Access Compliance Report

Public Rights-of-Way

(Curb Ramps)

Intersection ID: N/A	Main Street: SOUTHGROVE_ST	Cross Street: ARDREY_KELL_RD	Location: SW
ADA ID: 1C5800884051	Ramp Type: Directional1	Initial Pass/Fail: Fail	Overall Compliance: No
			Severity Score: 13.75

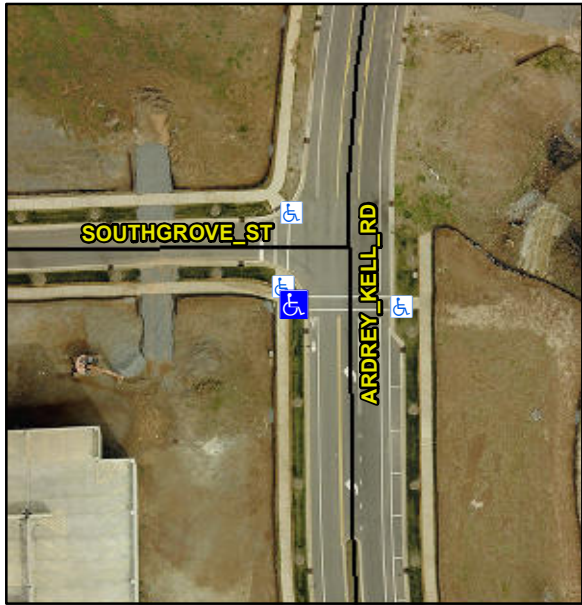
Codes/Mitigation Info/Possible Solution			Field Measurements/Component Compliance					
	Possible Solutions:		Compliance	Description	Data	Compliance	Description	Data
	Remove & Replace Entire Ramp.		N/A	Ramp Length (in)	82.0	N/A	Grade Break?	N/A
			Yes	Ramp Width (in)	57.0	N/A	Grade Break Slope (%)	0.0
			No	Ramp Slope (%)	8.9	N/A	Grade Break XSlope (%)	0.0
			No	Ramp XSlope (%)	3.6			
			N/A	Flare Type LT	N/A	N/A	Flare Type RT	N/A
			N/A	Flare Slope LT (%)	N/A	N/A	Flare Slope RT (%)	0.0
			N/A	Flare Traversable LT?	N/A	N/A	Flare Traversable RT?	N/A
	Surveyor Notes:		N/A	Landing Length (in)	0.0	N/A	DWS Provided?	N/A
			N/A	Landing Width (in)	0.0	N/A	DWS Contrast?	N/A
			N/A	Landing Slope (%)	0.0	N/A	DWS Length (in)	N/A
			N/A	Landing X Slope (%)	0.0	N/A	DWS Full Width?	N/A
	PROW/ADA:		N/A	Landing Curb? (Y/N)	N/A	N/A	DWS Offset LT (in)	N/A
	R304.2.2, R304.5.3		N/A	Shared Landing?	N/A	N/A	DWS Offset RT (in)	N/A
